APPENDIX A: Consultation Responses and Representations

Councillor Comments

Figure4 - proposed access points.

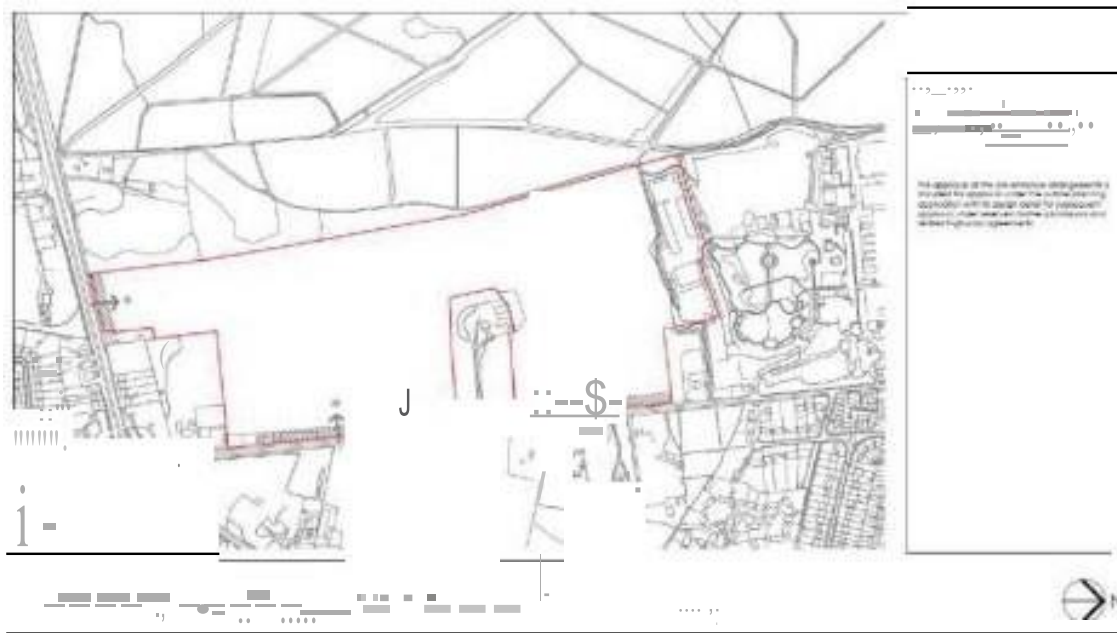
The applicants have confirmed that the locations of the access points are fixed by the overall parameter plans shown within figure 4 above.

The minimum spacing between access points is 152m between the visitor attraction access point and the service access, whilst the production area access sits 303m from the service access. A plan of the general layout of the proposed accesses is shown below in Figure 5.

Figure5- Access arrangement as proposed for Pinewood Road.

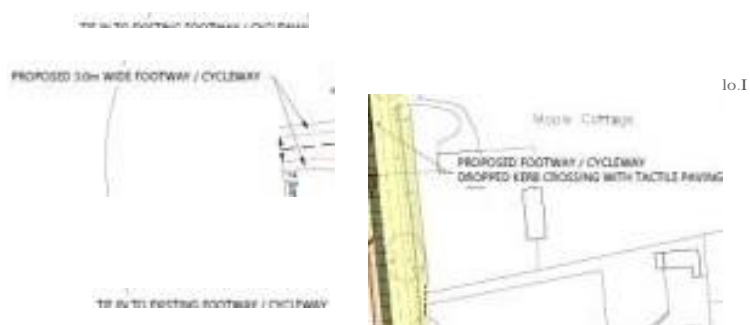
Each access point on Pinewood Road is proposed to have the same layout as shown within figure 5 and has been subject to a stage 1 Road Safety Audit (RSA). Review of the RSA1 did not identify significant issues with the junction design, however this office has provided initial feedback regarding the drawings as provided within the TA, that the swept path analysis of the left turn movement out of the site shows that this is not possible for a Public Service Vehicle (Bus or Coach) without crossing the centre line. As a result, the Highway Authority has requested that the radius of the junctions be modified to ensure that this movement can be contained within the northbound carriageway of Pinewood Road. The applicants have agreed to this and a revision to the RSA1 has been carried out.

Figure 1. Aerial photo of woodland belt along the peace path.

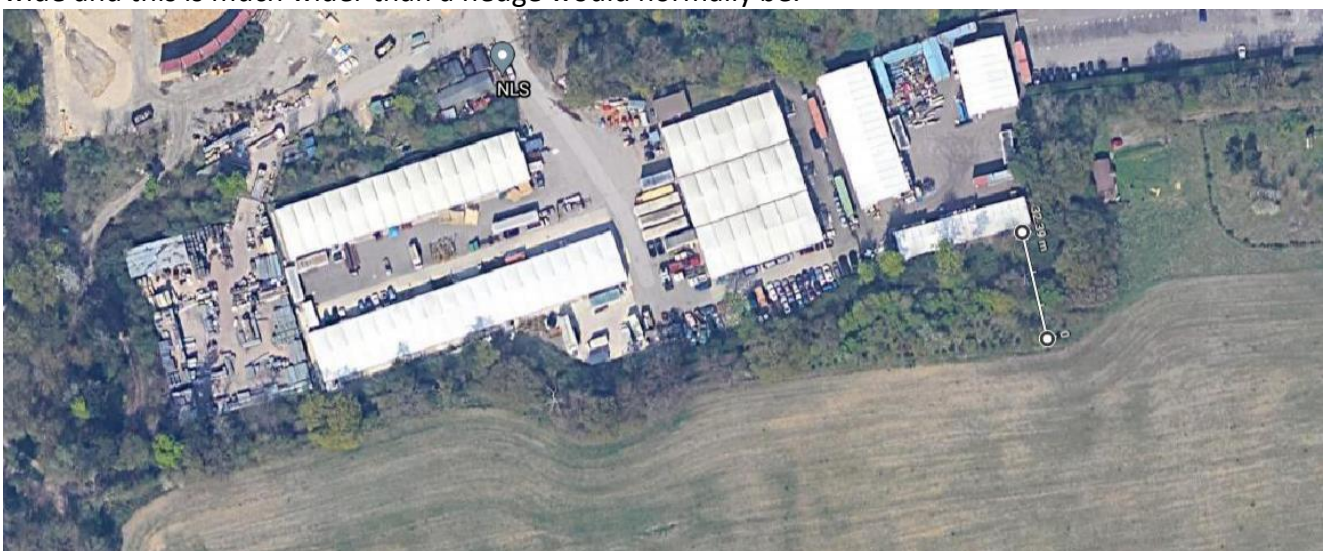
Particular areas for further explanation with regards to the baseline habitats relate to how woodland is assessed with regards to deer browsing and how the diversity of age structure is considered with regards the size of plants on the edge. Further consideration might also be necessary with regards to how the woodland belt along the northern edge of the site is identified. The submitted report and metric account for them as two lines of hedgerow and an area of scrub where as it is more likely that it should be identified as a strip of woodland as it is between approximately 15 and over 30 metres wide and this is much wider than a hedge would normally be.

It is highly likely that this would score quite differently as the aerial photos show that there are areas of young trees and also old trees with deadwood.

Figure 2. Image of PP4 – Green infrastructure plan (drawing reference: 3770-FB-SK-05-140920 Rev P3).

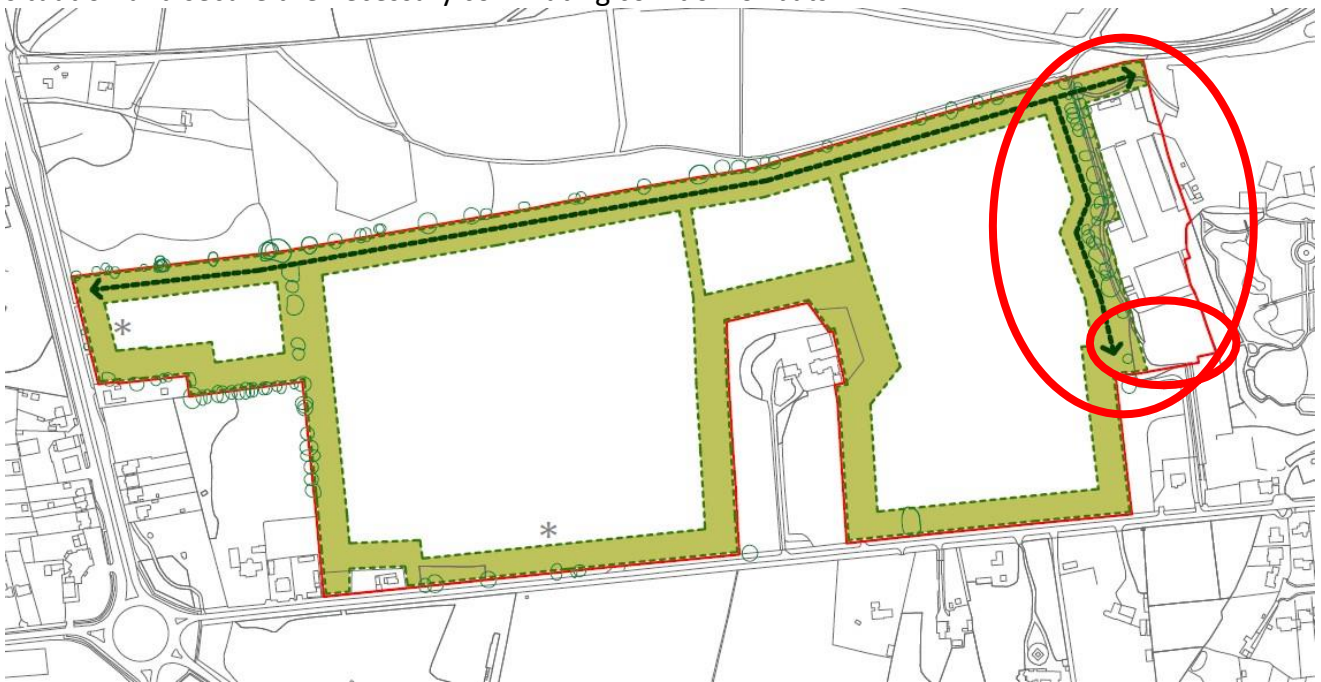
The smaller red circle shows an area where there is no proposed Green Infrastructure, however there should be additional planting in this area to maximise connectivity for commuting bats.

The Green Infrastructure link needs to extend from the peace path to the north east corner. The suggestion that on the plan that the dark corridor would only be limited to one east west connection and that here it would not extend the full width of the site is unacceptable. This would result in a broken connection for Bechstein's bats. Therefore conditions will be required to clarify the situation and secure the necessary commuting corridor for bats.
